NC ACCESSIBILITY CODE

2012 NC Bldg Code Ch. 11

2009 ICC/ANSI A117.1

Multi-Bldg New + Historic Residential

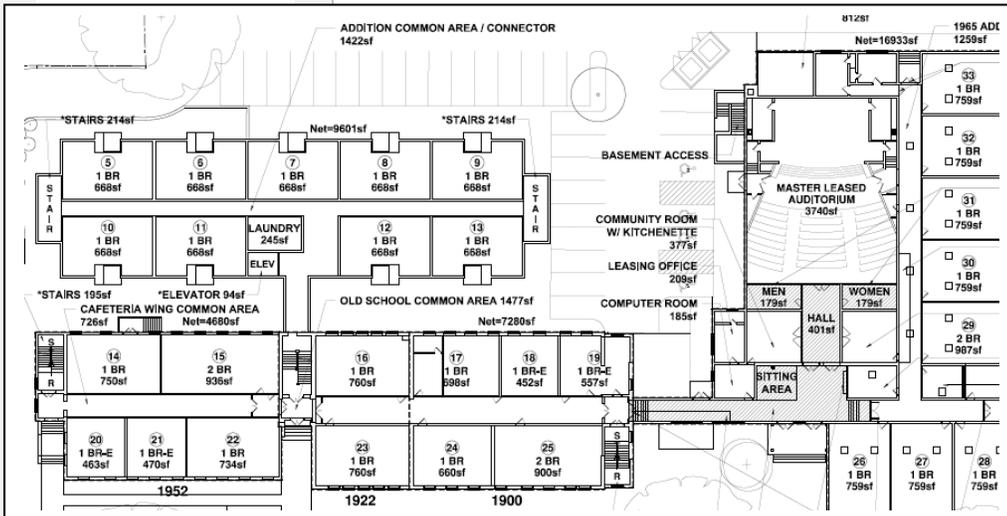
Q: The project is a historic rehabilitation of an old school, which will be converted to 31 apartments for seniors (not assisted but independent). In addition, there will be a new 22 unit apartment building constructed behind it. My understanding (or interpretation) is that in looking at the total project, we need 4 accessible units as required by **NCBC Table 1107.6.1.1**. However, if we look at it as separate buildings, we may only need 1 in the new bldg and 2 in the existing bldgs (built in 1900/1952 and in 1965). All of the new must be Type A or Type B, however in the existing, type A is required for one of each unit type, but the others are not required to be Type B or adaptable.

A: Generically, if the buildings all have the same bedroom types, the code references and calculations would be as follows:

However, since **NCBC 1107.6.2.1.1** requires that *Type A units* shall be dispersed among the various classes of units, the table below calculates the distribution of units for 1- and 2-bedrm dwelling units. The numbers under each building are totals of the dwelling units on a per floor basis.

ANSI 603.2.2 Turning Circle

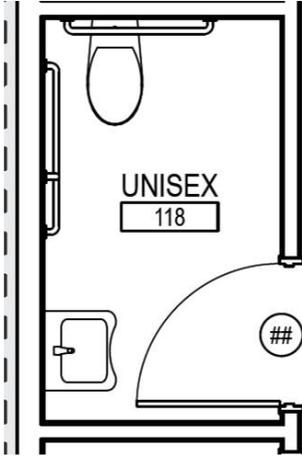
Q: Can the wall-mounted lavatory overlap the clear door area required inside the toilet room?

A: It depends on whether this is an individual toilet room or a stall/compartments.

Individual toilet room: **ANSI 603.2.2 Exc. 2** allows this with a 30" x 48" wheelchair space beyond the door swing.

NCBC 3411.7 Path of Travel Req'mts

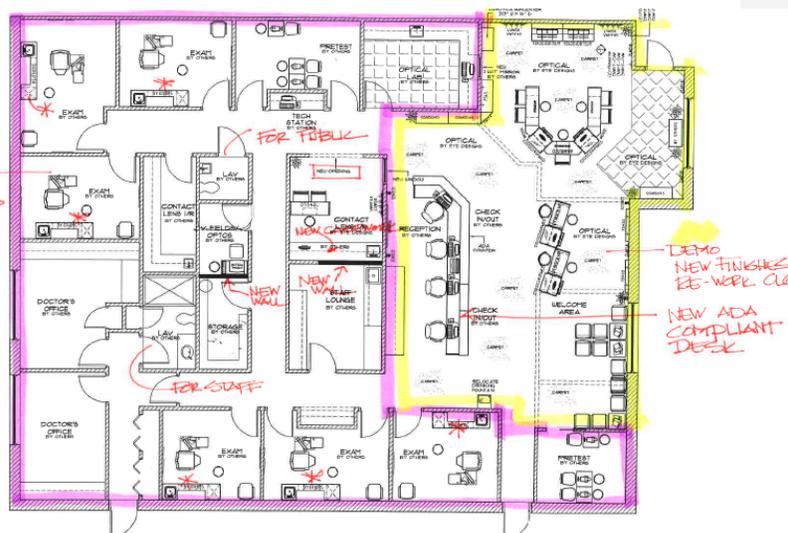
Q: The medical practice has been bought and they will be making changes, generally as shown on the attached plan. My question has to do with the restrooms. They are not up to current **2012 NCBC** code. Given that much of the renovation is being refreshed, with some new construction in the front area, will it be required to bring the public restroom up to current code compliance? The local plan reviewer said "No, you would not need to bring bathrooms up to code, if they still comply with code at time the building was built." Is this correct?

1. When alterations are done in an existing building, the following applies:
 - a. **NCBC 3411.5** requires that new construction shall apply to any additions within the building. Any additions affecting accessibility to or containing an area of primary function shall comply with **NCBC 3411.7**.

- b. **NCBC 3411.6** requires that the alterations shall comply with **NCBC Ch. 11** and **ANSI A117.1** unless technically infeasible. Where compliance is technically infeasible, then the alteration shall comply to the maximum extent feasible.

2. Path of travel upgrades for the alteration are to be calculated as follows:
 - a. The work in the reception area [the yellow bordered area] is new construction. That generates a design and construction budget, from which a 20% disproportionate amount is required to be calculated per **NCBC 3411.5** and **NCBC 3411.7 Exc. 1**.

- b. The work in the examination area [the purple bordered area] primarily consists of finishes with some new construction. If any of the work involved includes replacement of flooring material, that is considered an alteration and the budget for it is to be included when calculating the disproportionate amount. When each portion is separated out, the alteration portion will generate a design and construction budget, from which a 20% disproportionate amount is required to be calculated per **NCBC 3411.5**, **NCBC 3411.6** and **NCBC 3411.7 Exc. 1**.

3. The **NCBC 3411.7 Exc. 1** disproportionate amount garnered from the alterations in Items 2a and 2b above now are to be expended up to but not more than the resulting 20% calculated total. Since the work in the yellow Reception area is new construction, then the assumption is that any path of travel upgrades will be in the remaining area of the building where the alteration work, including the finishes (and the new walls were added). The typical list of path of travel upgrades is below. Where the earlier ones are accomplished, then proceed onto the others until all are provided or until the disproportionate amount is expended.
